Technical Bulletin

K02/K035468XS for PSA 1.8 and 2.0 16V engines

GATES REFERENCE:	K02/035468XS
MAKE:	CITROEN / FIAT / PEUGEOT
MODEL:	Evasion, Synergie, XM, Xantia, Xsara, ZX, Ulysse, 306, 406, 605, 806
ENGINE:	1.8 16V, 2.0 16V
ENGINE CODE:	XU7JP4, XU10J4R, XU10J4RS, RFV

Fig. 1 Manual tensioner (K025468XS)

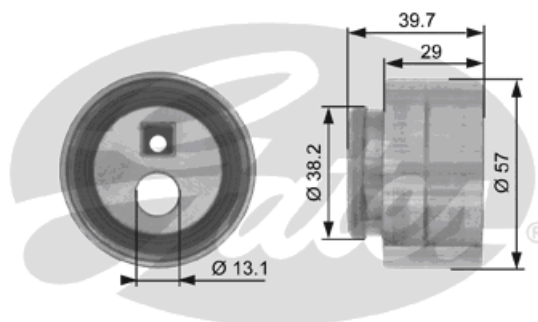
PowerGrip® Kit K025468XS is to be used for the PSA **2.0** 16V engines. This kit contains the original manual tensioner (OE ref. 082935, 9622574480. Gates ref. T41258). See Fig. 1.

Fig. 2 Automatic tensioner (K035468XS)

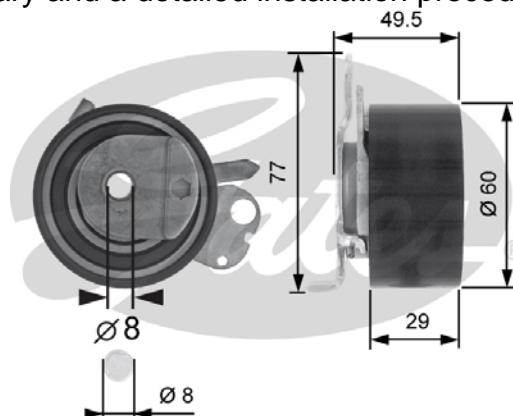
PowerGrip® Kit K035468XS is only suited for the PSA **1.8** 16V engines. It includes an automatic tensioner (OE ref. 082969, 9635336880. Gates ref. T43050 – see Fig. 2) as an upgrade to the initially installed manual tensioner. This replacement is recommended and also applied by Peugeot/Citroen so the manual tensioner should no longer be used on the 1.8 engine.

Fig. 3

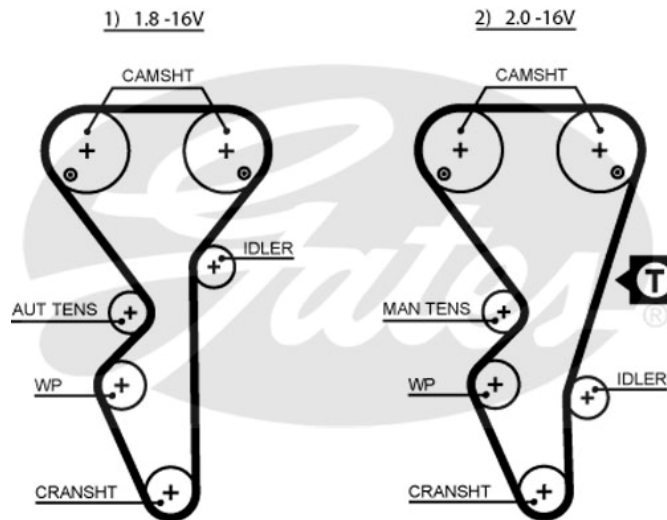
We found out that the drive lay outs we used up to now were not 100% correct: for the 2.0 16V engine, the idler position should be lower in the drive. The correct drawing is shown in Fig 3.

The tension on this 2.0 16V engine has to be checked (with Gates STT-1) between the right camshaft pulley and the idler (enter 5468XS-2).

Our drawings and recommendations on the timing belt/kit boxes will be adjusted accordingly
